MOTOR COACH  
INDUSTRIES

**SUBJECT: SAFETY RECALL OF WHEELCHAIR LIFT UPPER DOOR WARNING  
AND LATCH**

Ref.: **NHTSA # 09V-345  
TRANSPORT CANADA # 09-254  
MCI Service Bulletin 325B**

# Service Bulletin No. 325B

Figure 21. Schematic for non-multiplex coaches.

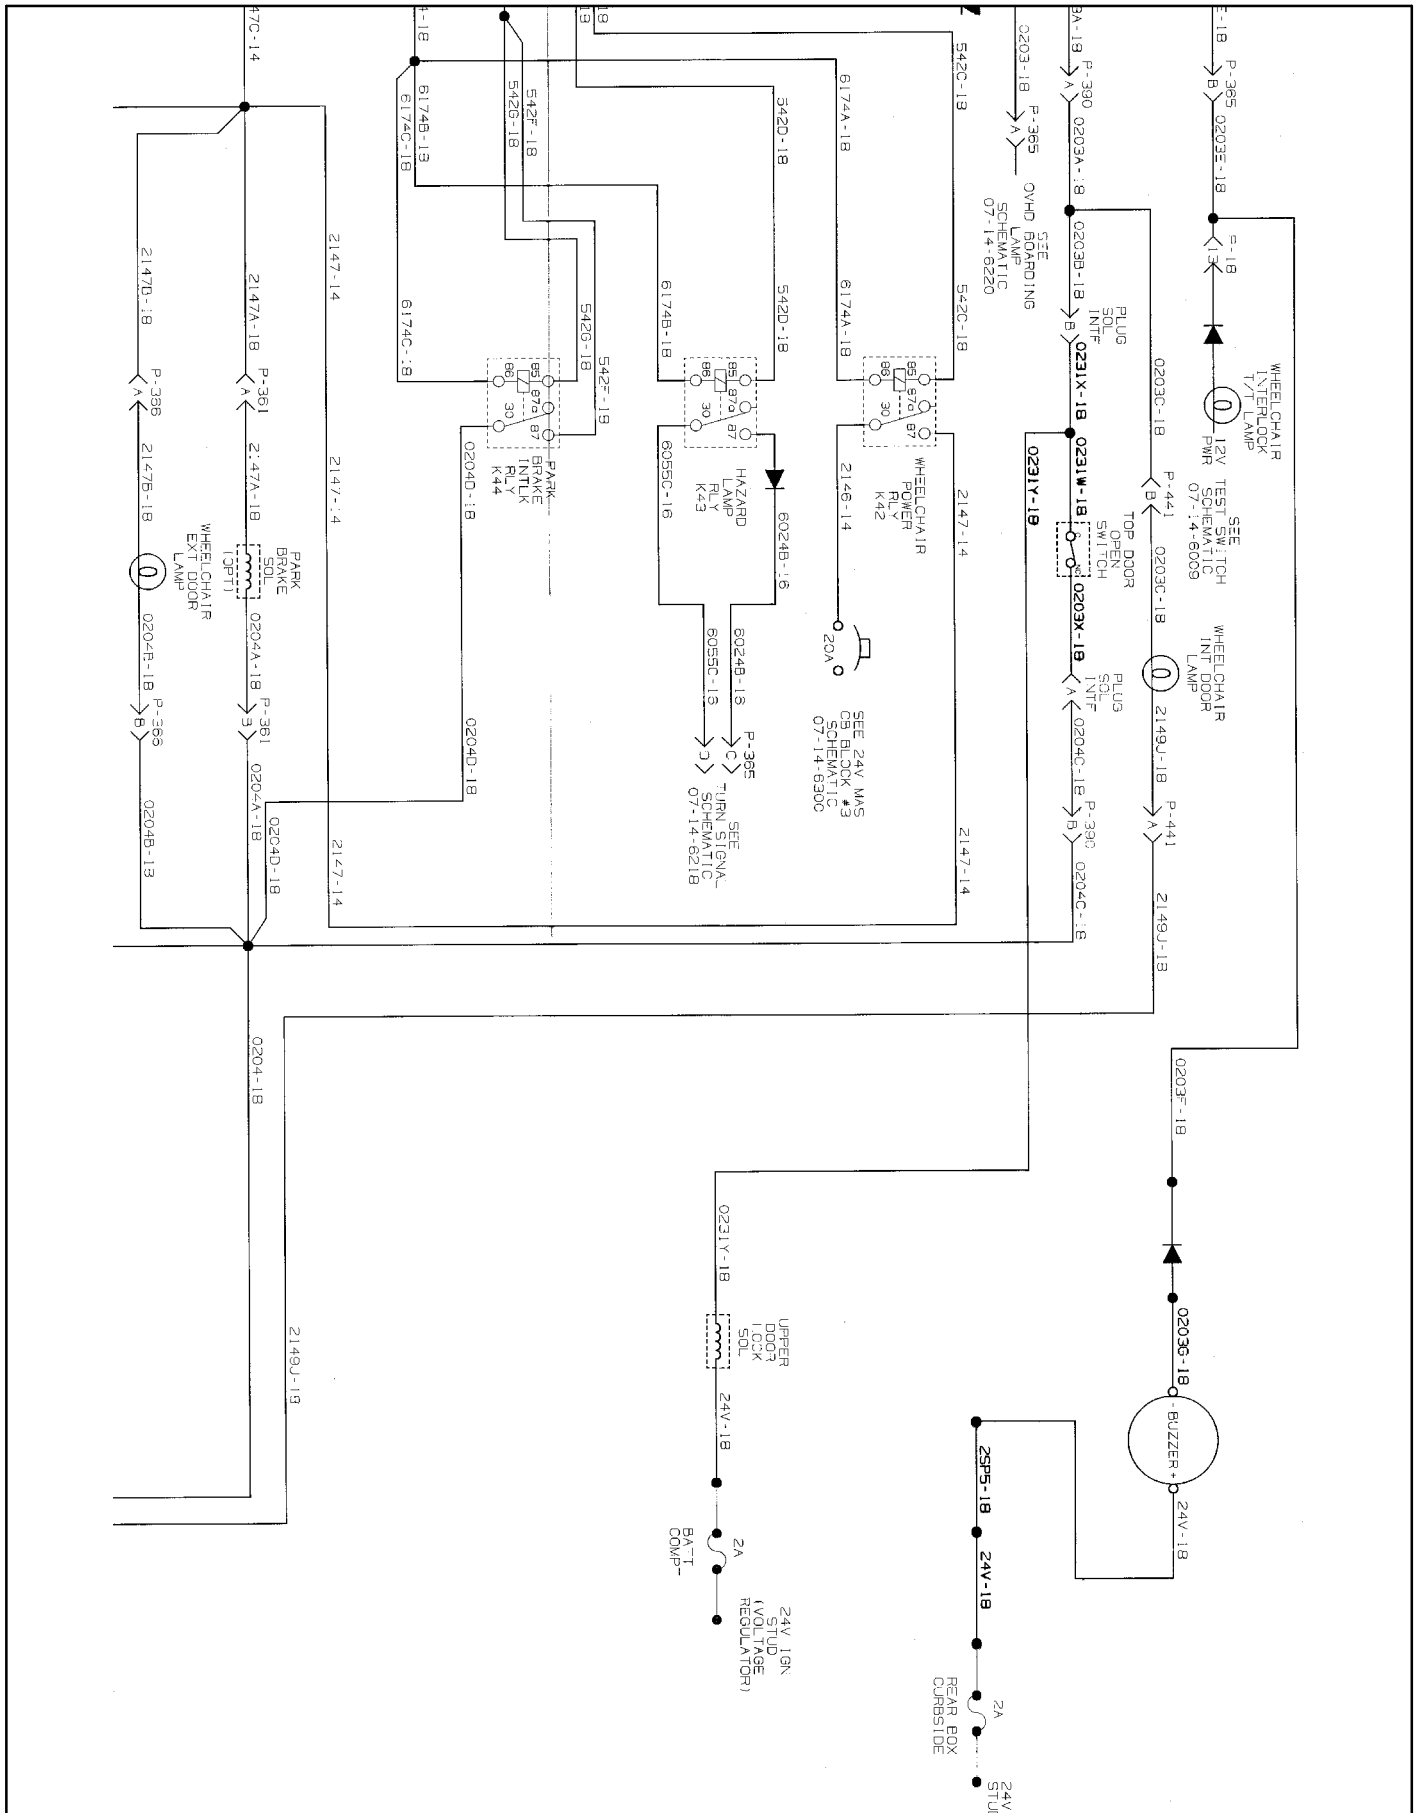
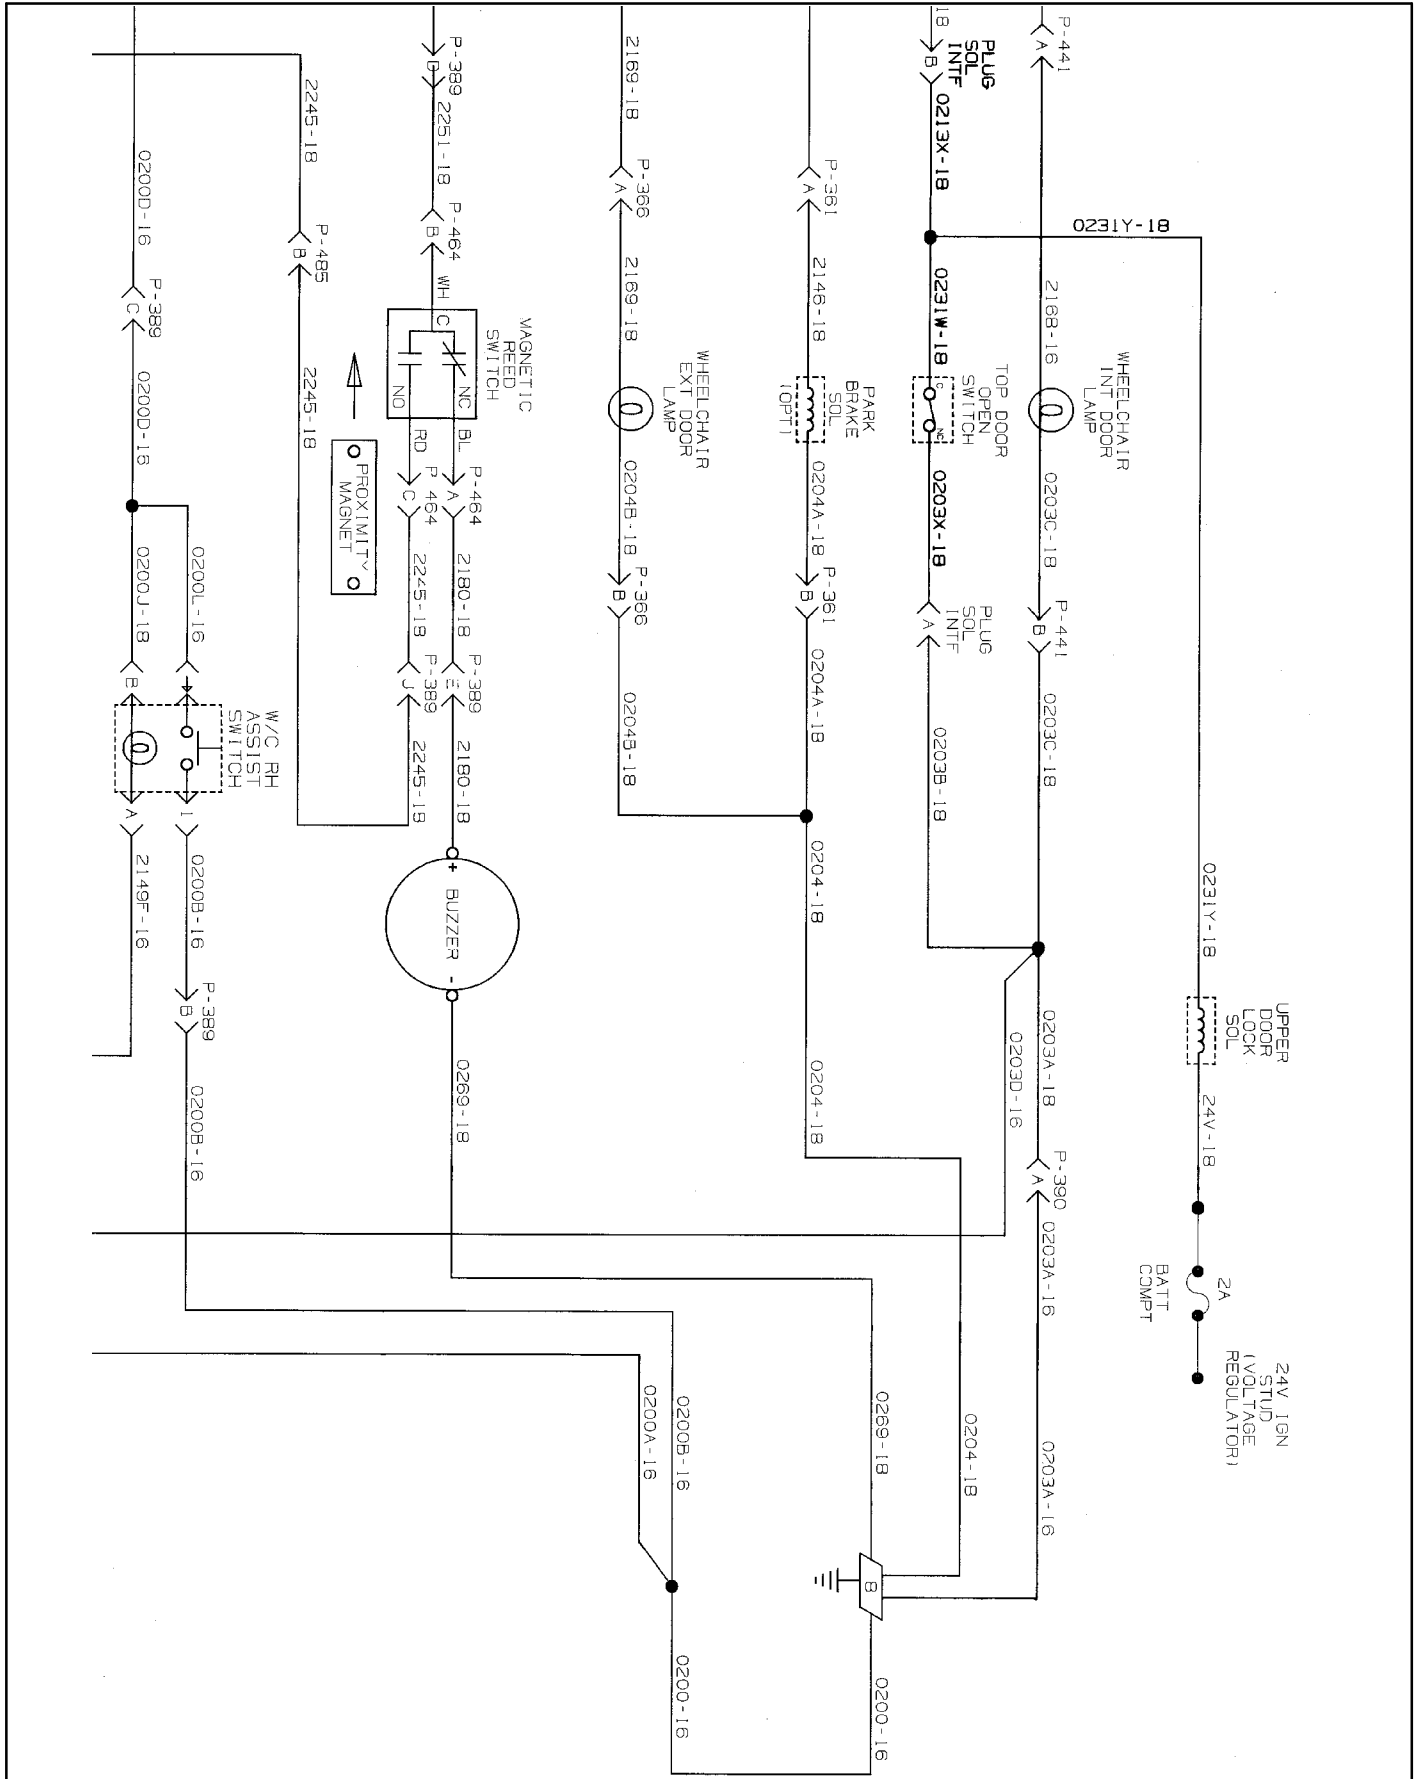
25. Use tywraps, p/n 19-11-569 throughout routing to secure harness to existing harnesses.
26. Remove ring terminals on existing harness that was disconnected in Step 20. Insert pins p/n 19-11-760, seals, p/n 19-11-2048, and connector, p/n 19-11-845 ( refer to schematics in Figure 21 or 22 ).

27. Route existing harness and connect to harness adapter, p/n 07-12-3066.
28. Connect solenoid adapter harness to the switch and actuator removed in Step 20. , the assy-solenoid p/n 03-31-3265, and the 24V ignition terminal on the voltage regulator ( refer to schematics in Figure 21 or 22 ).

**Figure 23.**

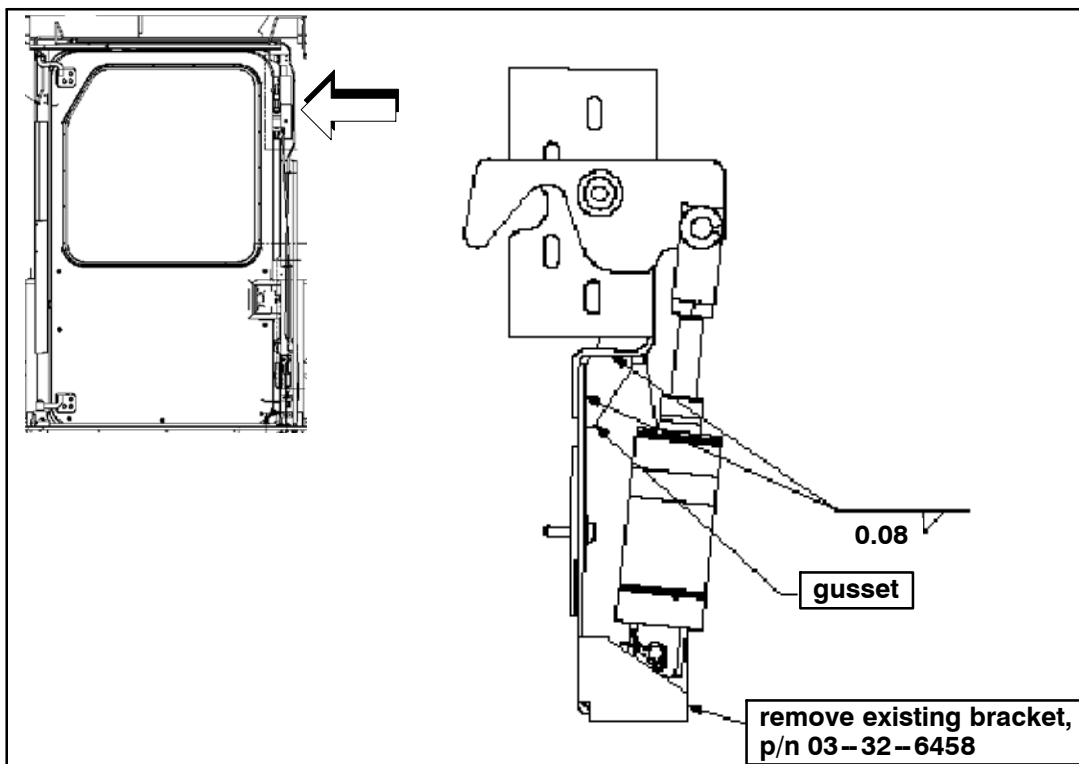
- 29. Remove existing bracket assy–cylinder upper, p/n 03–32–6458, from door ( refer to Figure 23 ) and place on a workbench. Retain mounting hardware.
- 30. Position gusset, p/n 03–31–3261, as shown in Figure 23. Weld gusset flush on existing bracket assy–cylinder upper as per specifications shown in Figure 23.

**Figure 24.**

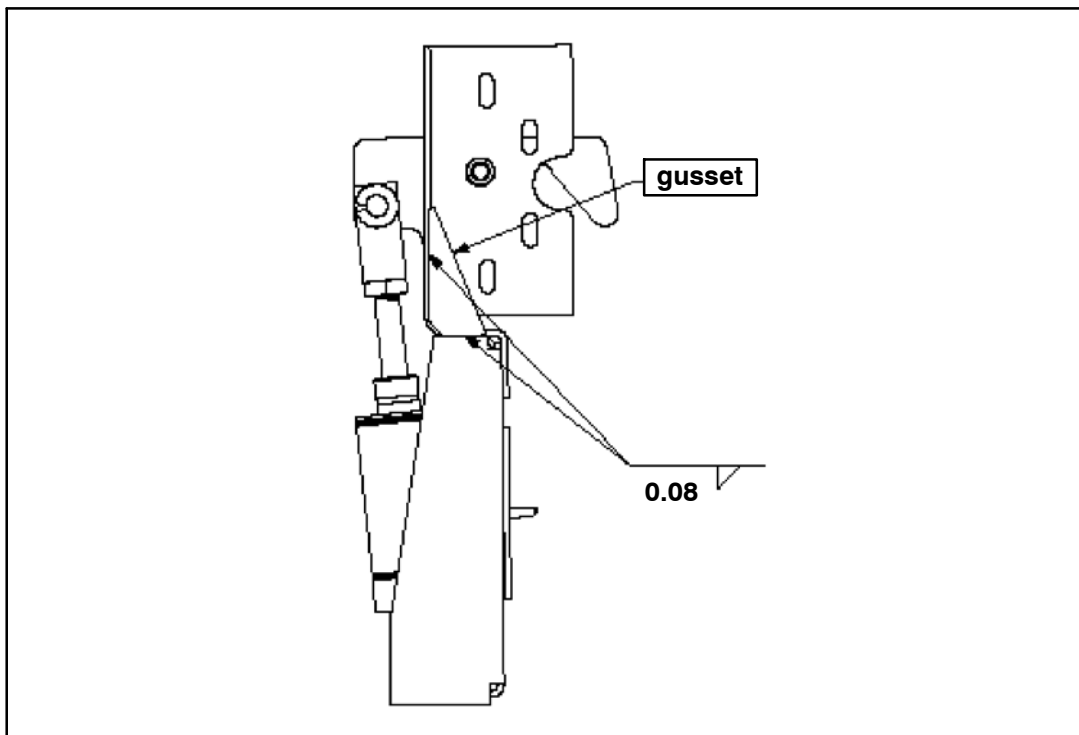
- 31. Position gusset, p/n 03–31–3260, as shown in Figure 24. Weld gusset flush on existing bracket assy–cylinder upper as per specifications shown in Figure 24.

Figure 25.

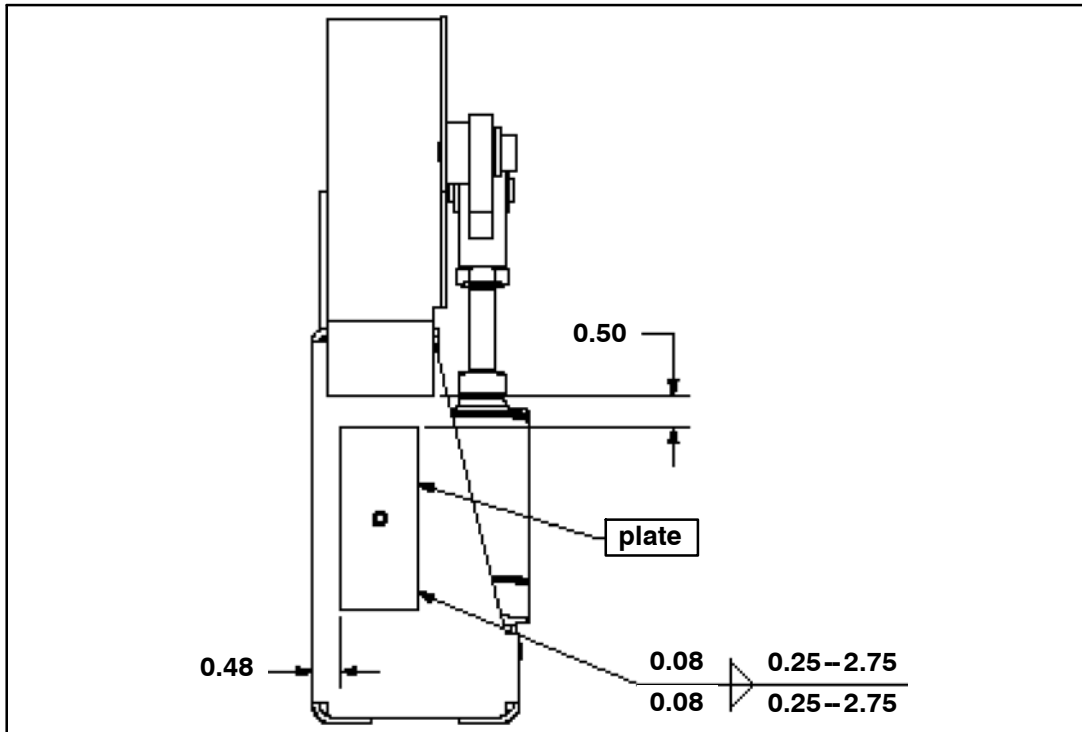
32. Position plate, p/n 03-31-3259, as per dimensions shown in Figure 25. Weld plate on existing bracket assy-cylinder upper as per specifications shown in Figure 25

**Figure 27.**

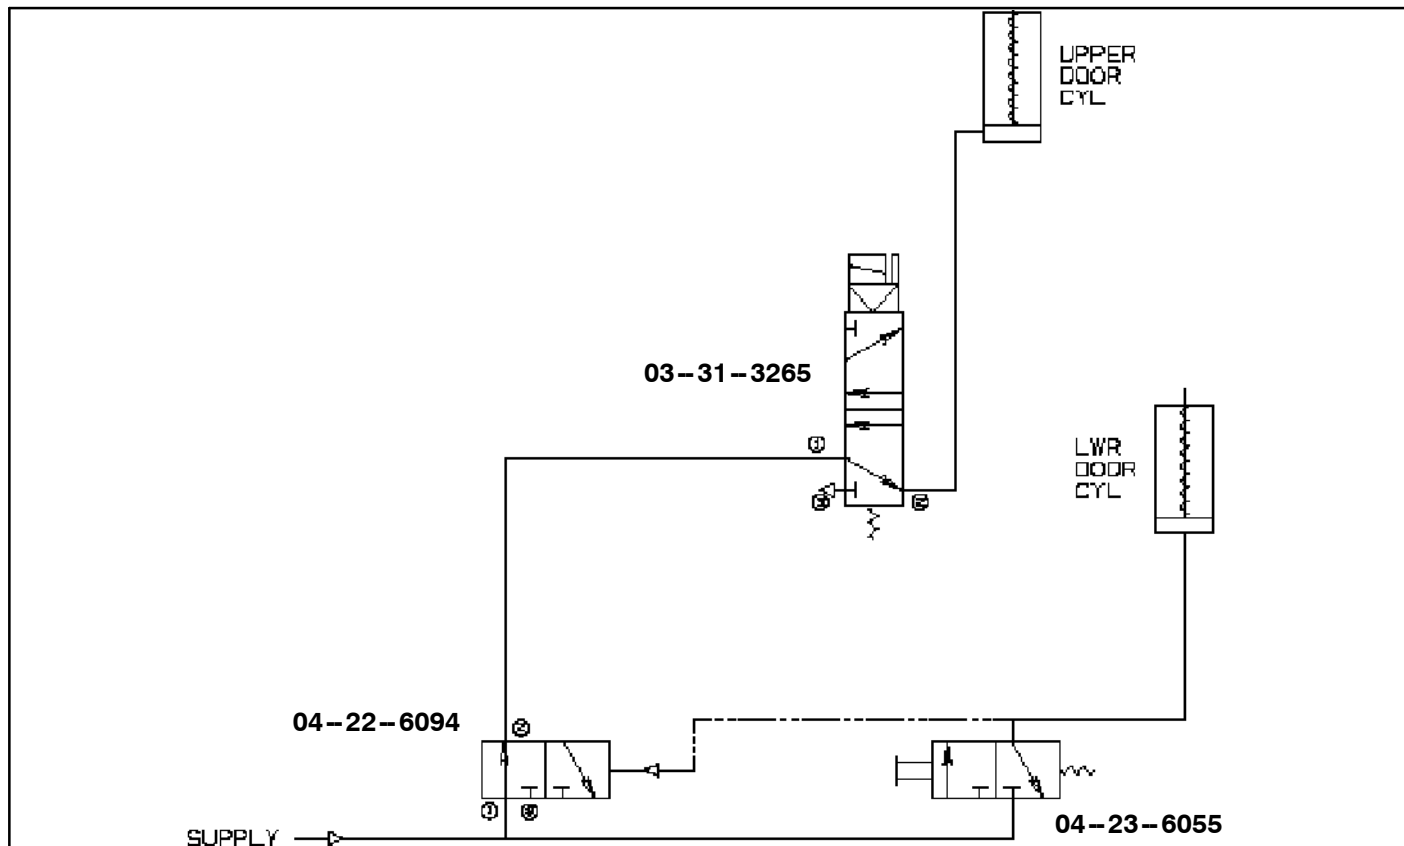
37. Route a 24 inch piece of tubing–airline, ¼ black, p/n 21–7408–155, between the existing valve, p/n 04–22–6094 and assy–solenoid 03–31–3265 ( refer to Figure 27 ). Pass tubing–airline through grommet and then connect with assy–solenoid 03–31–3265 ( refer to Figure 27 ).

**Figure 29.**

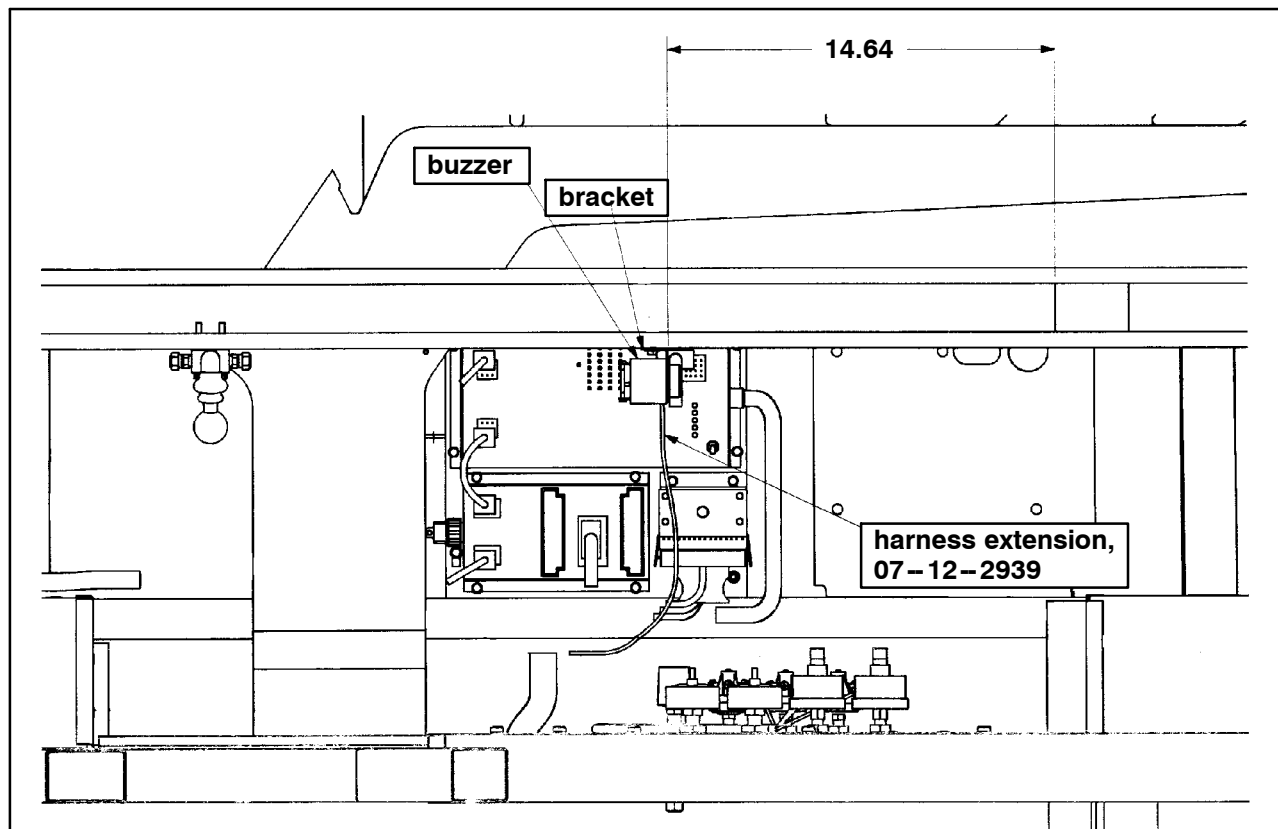
- 45. Using a 0.149 dia. drill bit and the holes on the bracket, p/n 07-08-2796, as a template, drill two (2) holes at dimension shown in Figure 29. Using screws, p/n 19-1-758, install the bracket, p/n 07-08-2796.

**Figure 35.**

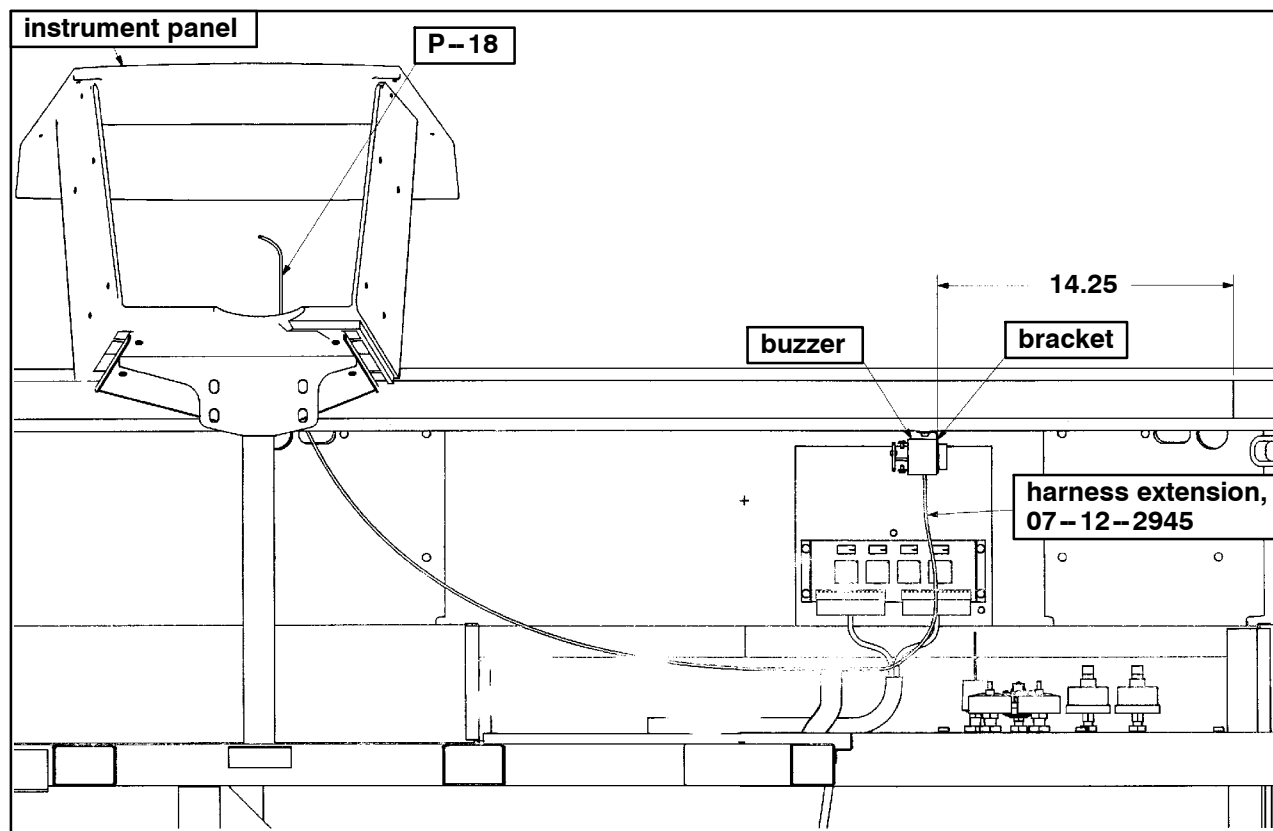
59. Using a 0.149 dia. drill bit and the holes on the bracket, p/n 07-08-2796, as a template, drill two (2) holes at dimension shown in Figure 35. Using screws, p/n 19-1-758, install the bracket, p/n 07-08-2796.
